DART SERVICE BULLETIN SB11-1

AFFECTING:
D412-791-047 PITOT HEAT MONITORING KIT
REF TCCA STC: SH09-37
REF FAA STC: SR02766NY
REF EASA STC: 10032253

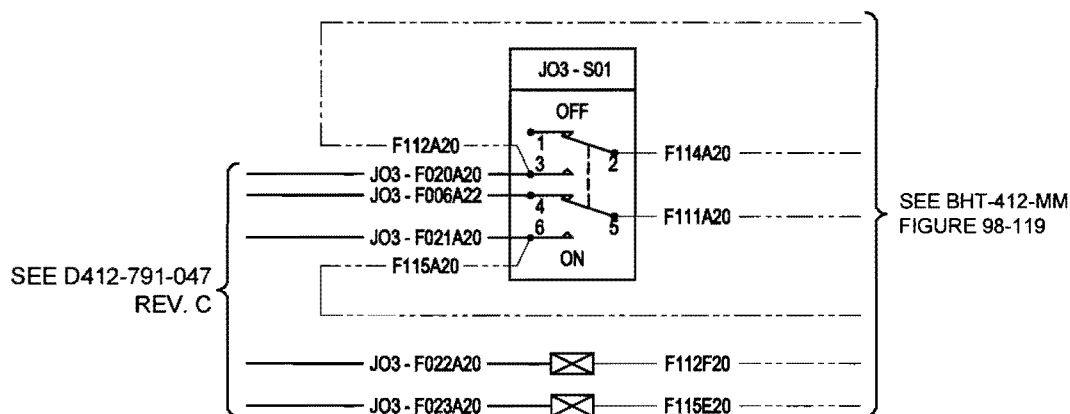
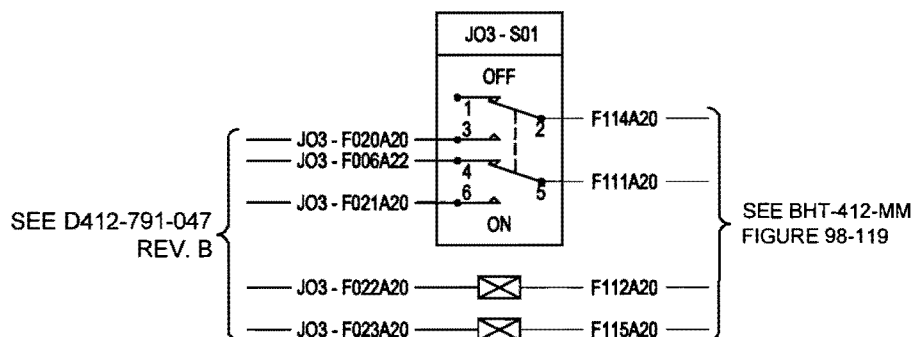
WHEN D412-791-047 WAS INSTALLED ON **BELL 412 S/N 33101 - SUB**, THE PITOT HEAT MONITOR WOULD FAIL TO RECOGNIZE A POSSIBLE LOW CURRENT SITUATION. WHEN THE STATIC HEAT WAS CONNECTED TO THE CURRENT SENSING RELAY, THE LOW CURRENT OF THE PITOT HEAT WOULD NOT BE PROPERLY DETECTED.

REWIRE THE INSTALLATION IN ACCORDANCE WITH D412-791-907 REV. C.
